Office Action Summary

10/551,802

SUGAHARA ET AL.

DETAILED ACTION

Prior Art: Lee Figure 11

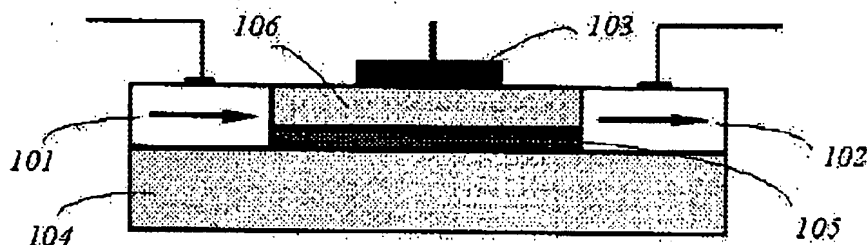
26. Per **Claim 35** Lee discloses a transistor, comprising a ferromagnetic semiconductor layer, a source (101) that injects carriers into the ferromagnetic semiconductor layer; and a drain (102) that receives the carriers injected into the ferromagnetic semiconductor layer a gate electrode (103) that applies a voltage for controlling conduction of the carriers from the source to the drain [0059]. Lee [0058] teaches that the ferromagnetic semiconductor material can be changed to have a ferromagnetic property or to have a non-ferromagnetic property by controlling a carrier concentration with a gate voltage. With this understanding, the device of Lee discloses combinations of ferromagnetic and/or non-ferromagnetic sources and drains.

27. Per **Claims 37 and 42** Lee discloses the transistor of claim 35, including where when the source is the ferromagnetic source, the drain is a non-magnetic drain that comprises a non-magnetic tunnel barrier (106) joined to the ferromagnetic semiconductor layer, and a non-magnetic electrode (103) joined to the non-magnetic tunnel barrier .

28. Per **Claims 38 and 43** Lee discloses the transistor of claim 35, including where when the drain is the ferromagnetic drain, the source is a non-magnetic source that comprises a non-magnetic tunnel barrier (106) joined to the ferromagnetic semiconductor layer, and a non-magnetic electrode (103) joined to the non-magnetic tunnel barrier .

44. Per **Claims 55 and 57** Lee discloses the transistor of claim 54, including where the transistor is formed on the substrate; the junction interface of the source and the drain in the vicinity of the gate electrode is substantially perpendicular to the principal surface of the substrate; and the flowing direction of the carriers moving from the source to the drain is in a plane substantially parallel to the principal surface of the substrate. (As shown in figure 11)

45. Per **Claim 56** Lee discloses the transistor of claim 54, including where the electrode (103) is separated from the ferromagnetic semiconductor layer (105) and the substrate (104) by the tunnel barrier (106).

46. Per **Claim 61** Lee discloses the transistor of claim 54, including where the transistor is formed on the substrate; the junction interface of the source and the drain with the ferromagnetic semiconductor in the vicinity of the gate electrode is substantially parallel to the principal surface of the substrate; and the flowing direction of the carriers moving from the source to the drain is in a plane substantially parallel to the principal surface of the substrate. (see figure 11)
